# Partial Channel Model Impacts on COM for CR Channels

Sam Kocsis, Amphenol

*Related to comments #393 and 466*

| CI 179            | SC 179.11.7.1   | P 394             | L 27 | # 466 |

Figure 178A-1—Channel considered for the calculation of COM

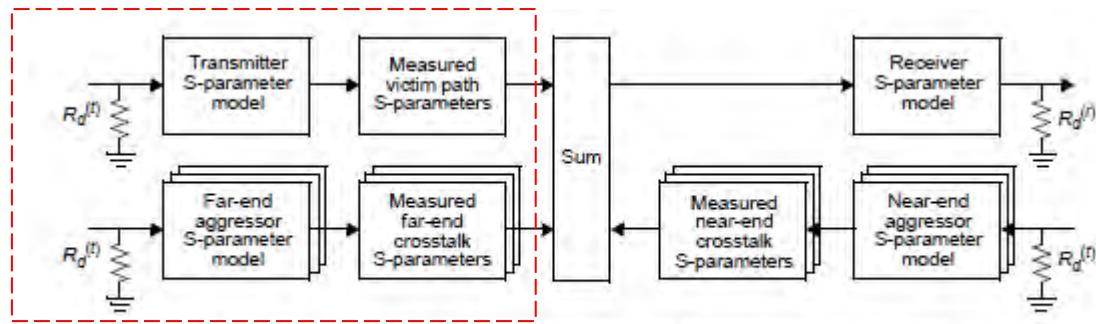
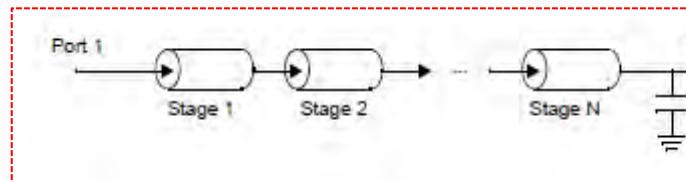
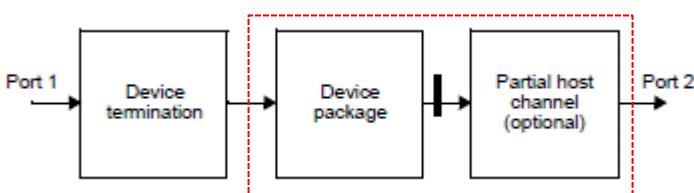
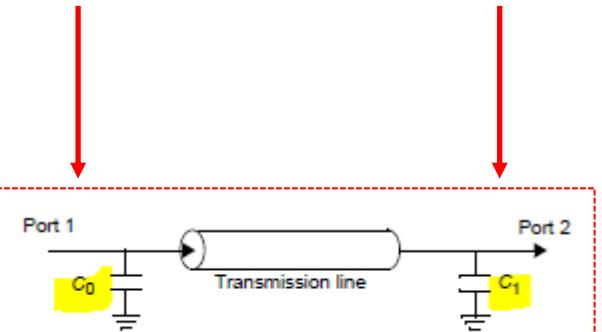
C0 is physically  
abutted next to Cp

C1 is physically  
abutted next to TP1

- There are currently (0) models posted to the TF page for CR (TP1-TP4)
- [Lim 3dj 01a 2409](#) was used define the partial host channel model
- The decision was justified, but failed to correctly look at C0 and C1
  - If C0 is a package parameter, it should be compliance parameter setting applied for TX, RX, and KR testing
  - C1 is neither a package parameter, nor explicitly a “connector via”
  - If C0 and C1 are to remain only normative for CR (TP1-TP4) tests, the decision should take into the impact on TP1-TP4 data

|                   | Set to 0, OR remove C0 and C1 parameters  |                   |      |       |

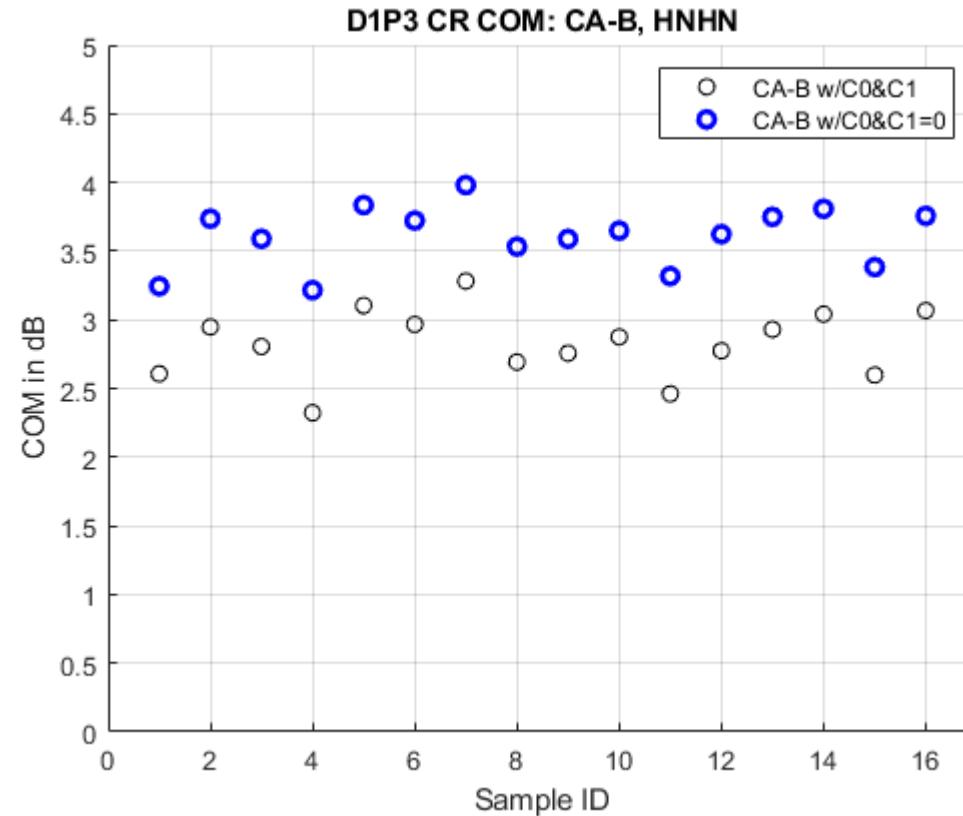
*C0 and C1 parameters changed, all other parameters remain same*

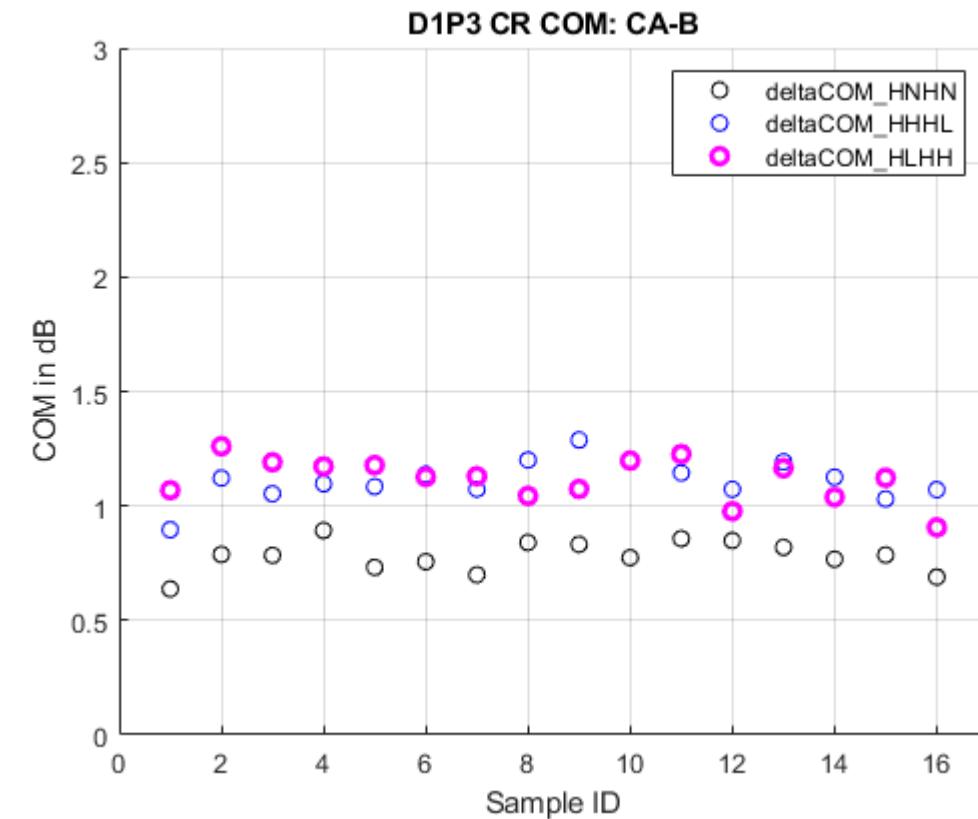
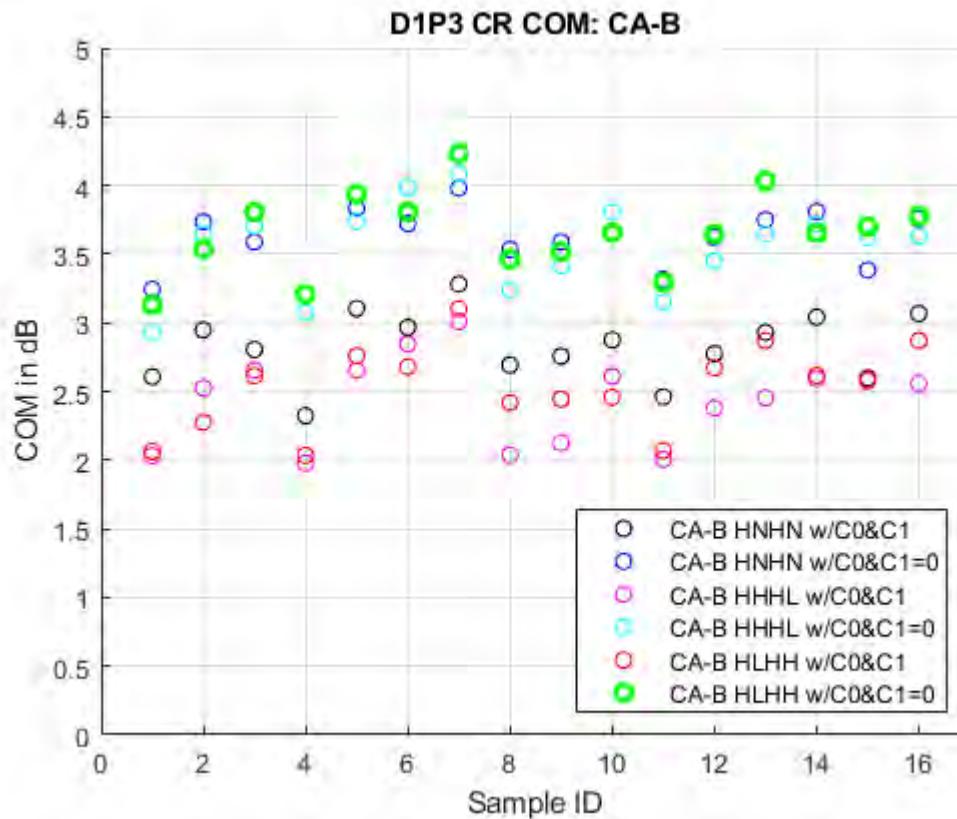
*Delta COM is highest for the asymmetric cases*

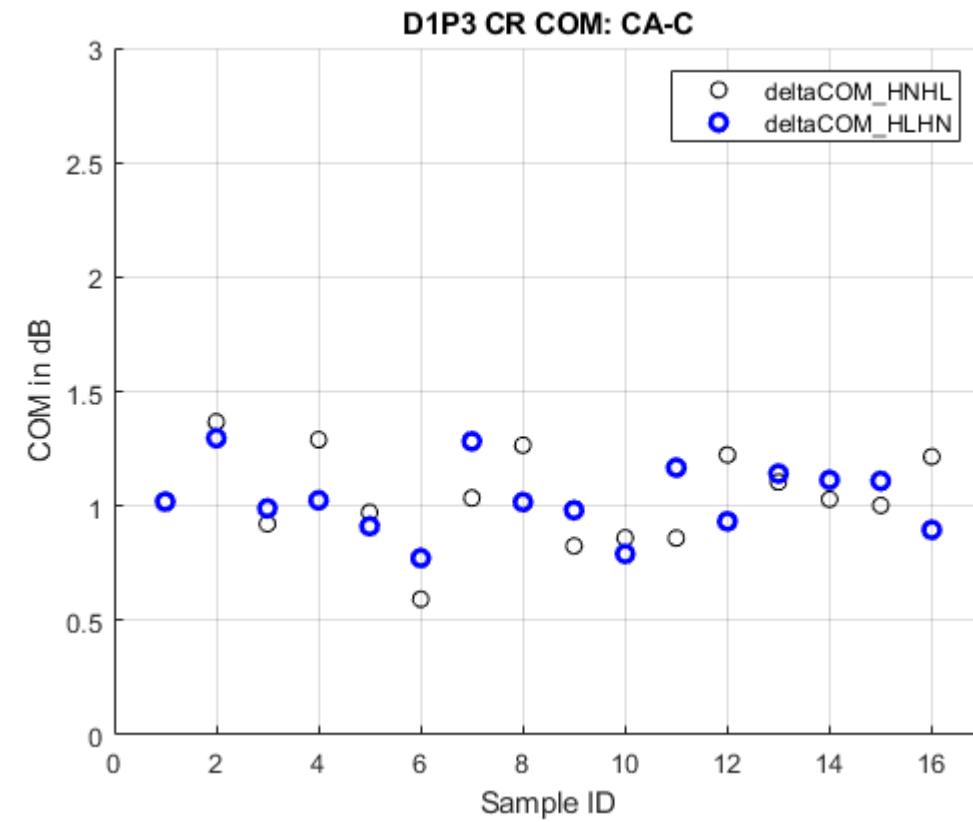
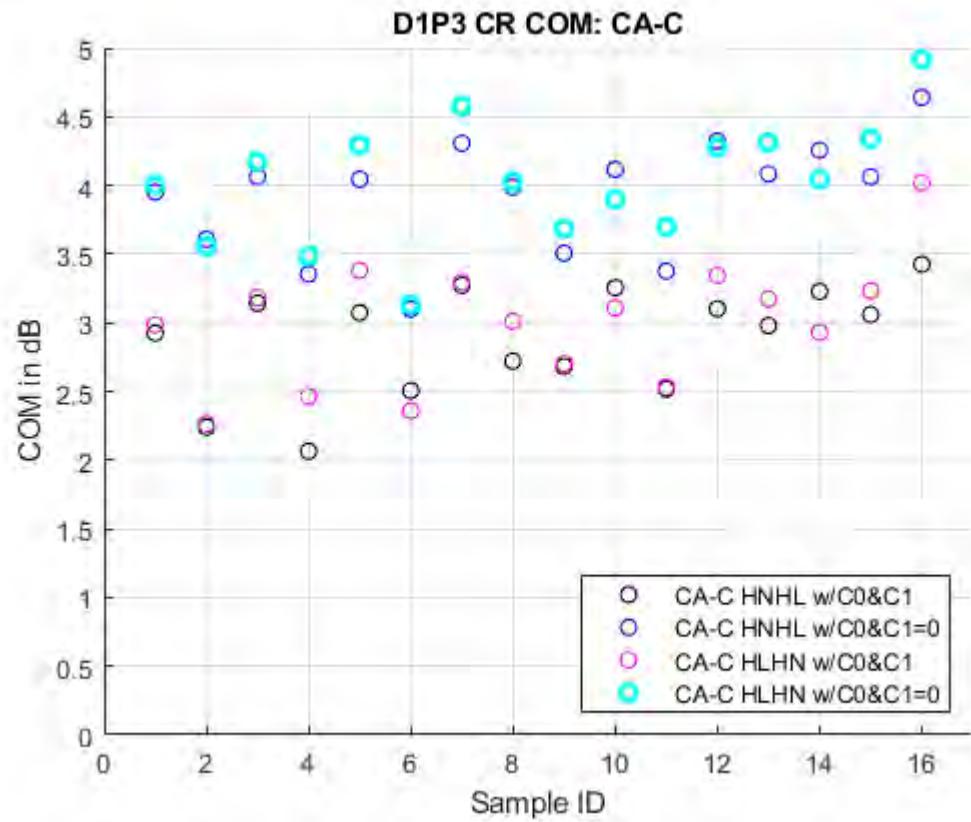
*Delta COM is trend is similar for physically longer CA types*

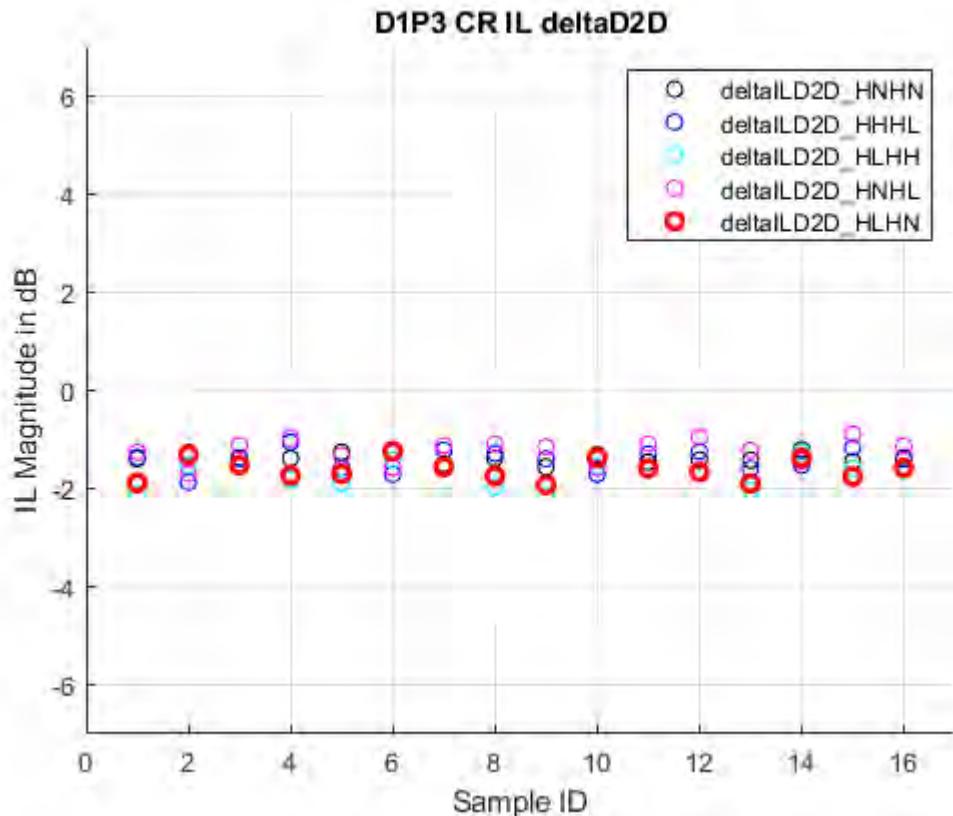
The impact of C0 and C1 is not consistent across lanes

Changing C0 and C1 values will likely lead to a change for the partial host channel model parameters, *below*

For cases where  $C0, C1=0$ ,  $ILD2D < 40dB$

- There are no cases where C0 and C1 “help” CR COM results
  - As defined in D1P3
- C0 and C1 are poorly defined in D1P3 and unequally stress CR (versus KR) and asymmetric (versus symmetric) test cases
- Further work needs to be done to determine the right allocations between package IL (mm), PCB IL (mm) for cases HL, HN, and HH
  - And continue to address more CA types, channel combinations, and settings
- **Propose to set C0 and C1 = 0 and let future drafts update other parameters as necessary, as written in comment 466**
